Docket Item # 6  
BAR CASE # 2008-0095

BAR Meeting  
September 17, 2008

**ISSUE:** Addition and Alterations  
**APPLICANT:** Stephanie Dimond  
**LOCATION:** 725 South Columbus Street  
**ZONE:** RM/Residential

Figure 1: Plat showing area of demolition/addition

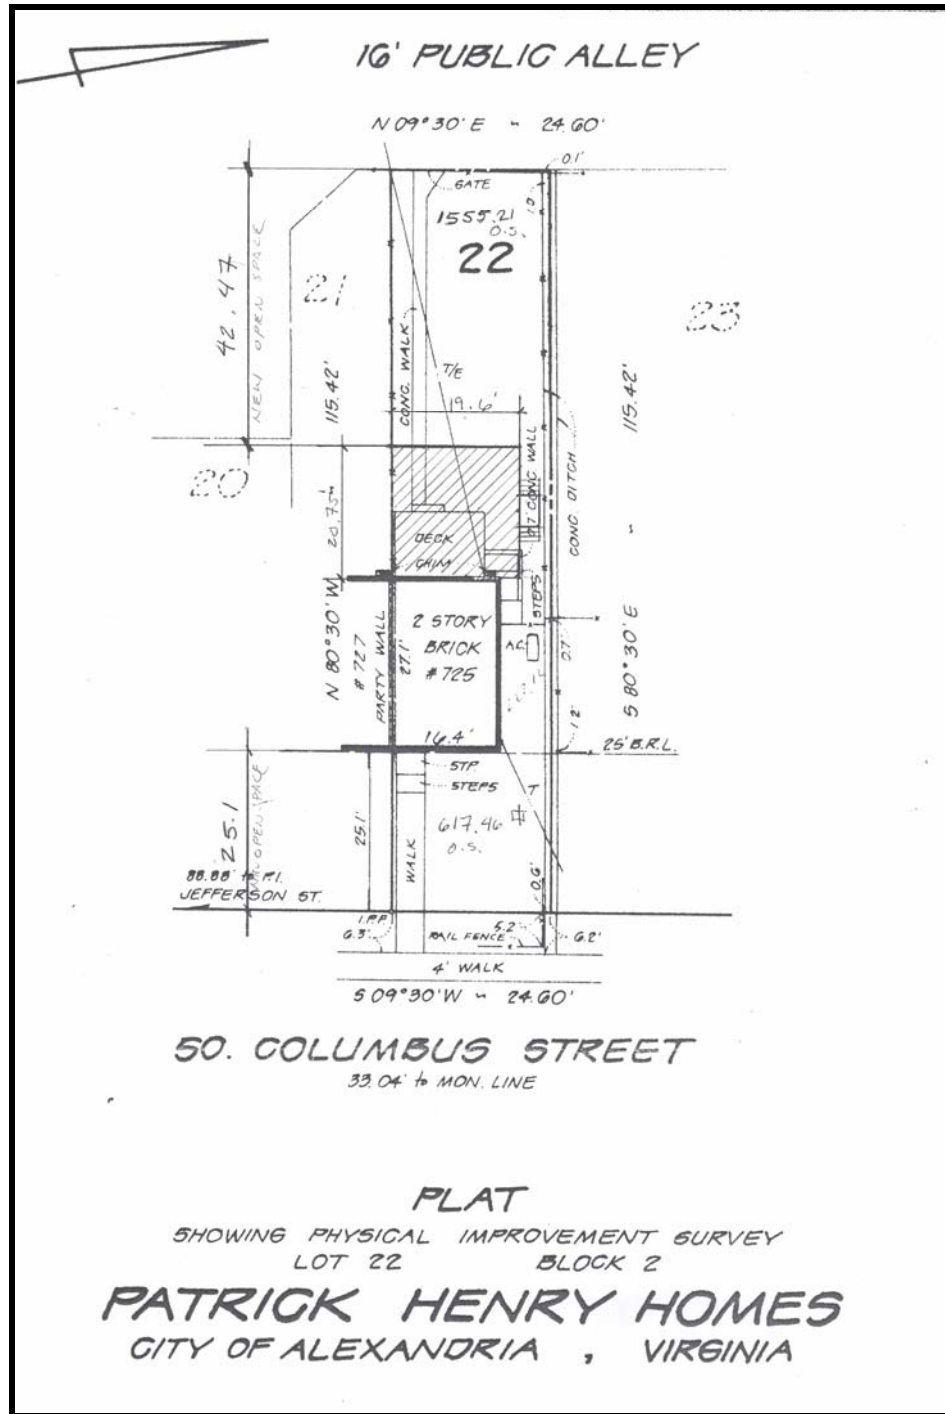
Staff does acknowledge the impact the proposed addition will have on the applicant's immediate neighbors. The proposed addition will be visible through an approximately 17 ft gap between 721 and 725 South Columbus Street. The addition will be most noticeable from the rear yards of the houses on South Alfred Street and from the rear alley behind the property, which is very narrow and utilitarian in nature with vegetation and 6' fences throughout, some located on raised brick walls.

Figure 3. Open space with proposed addition.

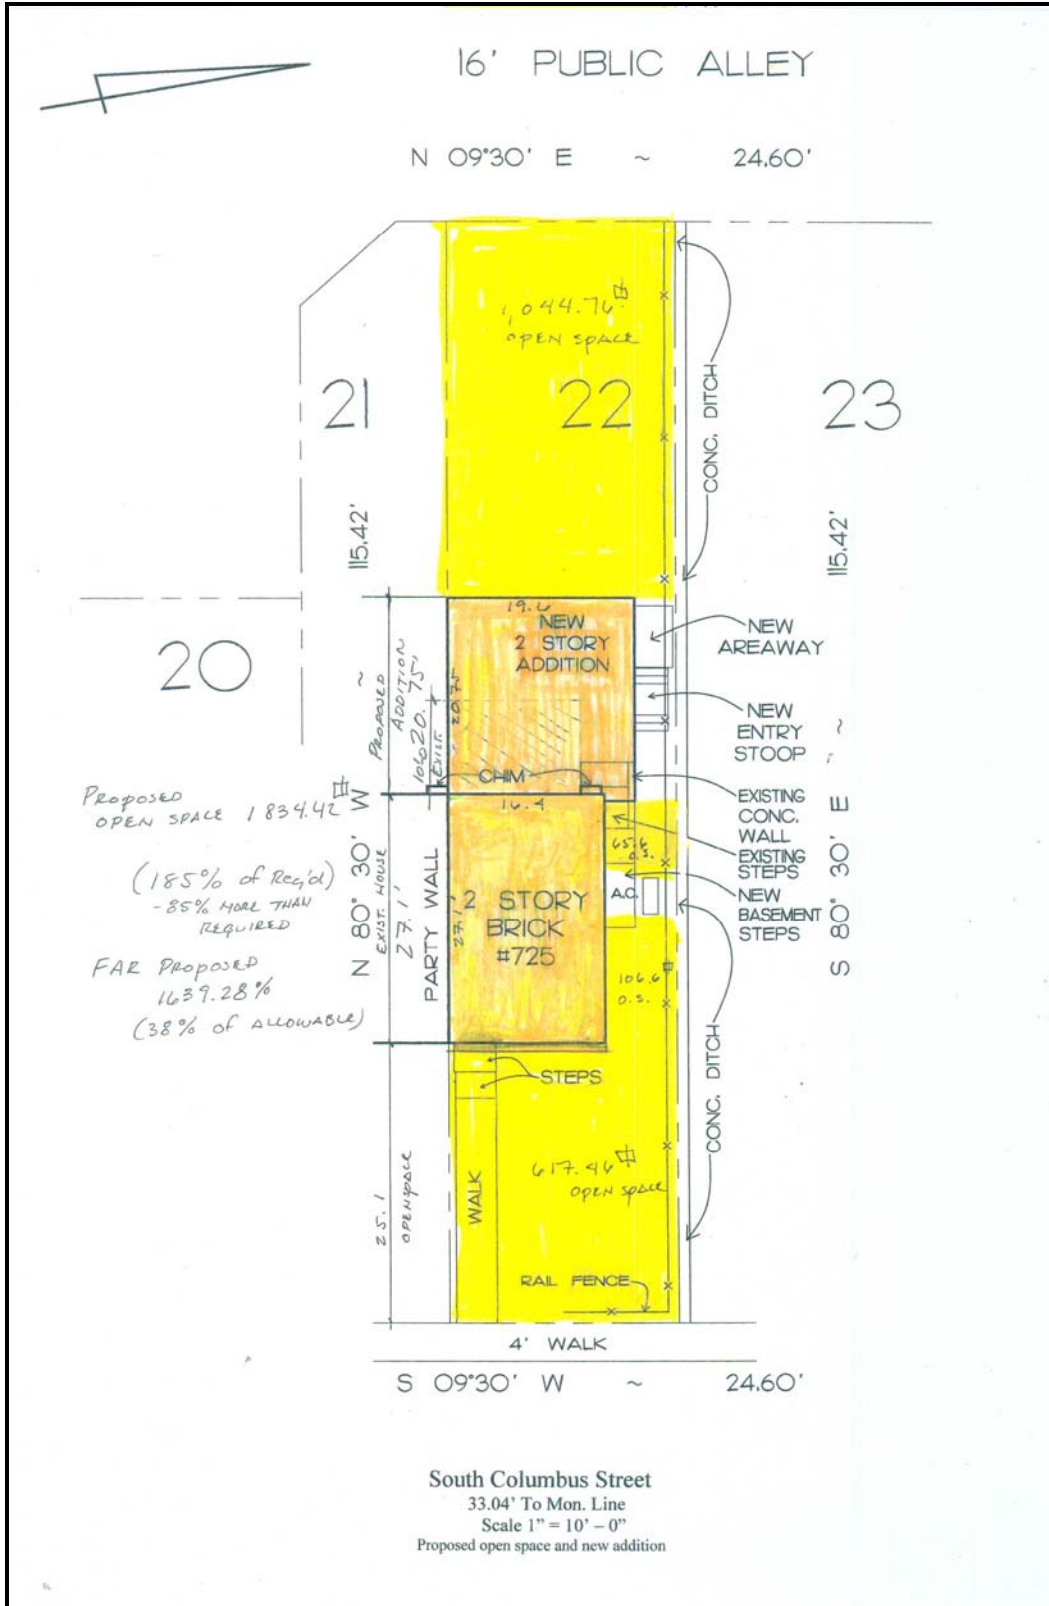
Since the last Board meeting in July, the applicant has provided additional information intended to demonstrate that, with the addition, the property will still have an excess of open space and FAR (floor area ratio) as required in the RM zone. The applicant's material outlines that the resulting open space will be 85% more than what is required by the zoning ordinance (993 square feet required vs. 1,834 square feet provided) and the new FAR is just 38% of what is allowed under the zoning ordinance (4,285 square feet allowed vs. 1,639 square feet provided). Staff does point out that the zoning ordinance establishes only the absolute limitations and *minimum/maximum* standards and it is the Board's role to evaluate the addition in terms of scale, mass and compatibility.

Figure 7. Proposed elevations.

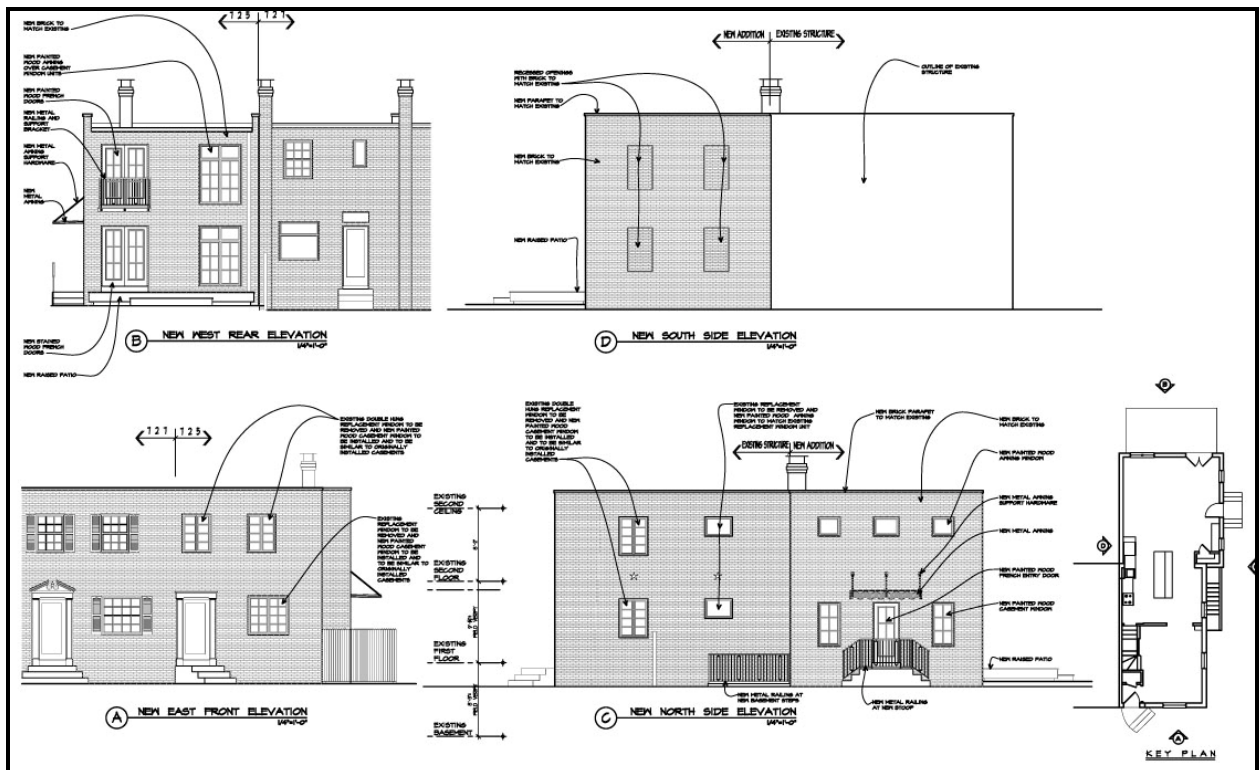
Update: At the July 9, 2008 BAR hearing, the Board expressed concerns with the mass of the proposed addition and the lack of articulation on the addition's south elevation, and asked the applicant to explore ways to address these concerns. The applicant has submitted additional information which shows the articulation of the south elevation of the addition with recessed faux windows. In addition, the submitted materials include a further justification of the size and mass of the addition as it relates to the surrounding neighborhood.

The south elevation of the addition has been revised to include two recessed faux windows on both the first and second floors. The recessed panels are intended to give the appearance of former window openings.

In the opinion of Staff, the proposed addition is appropriate and compatible with the two story townhouse at 725 South Columbus Street and conforms to the *Design Guidelines* for residential additions. The design of the addition is compatible in style, material and fenestration with the existing brick townhouse. The simplistic geometric form of the addition expresses the "prevailing shape" of the original building, as discussed in the *Guidelines*. The *Guidelines* also

recommend that new additions be differentiated from the existing buildings, and Staff believes the applicant has achieved this by, in the words of the applicant, "...offsetting the footprint of the addition to break the wall plane..." While the addition introduces a new mass into the rear yard, it retains the integrity of the historic portion of the house by maintaining the uniform massing of the blockface as recommend in the *Design Guidelines*.
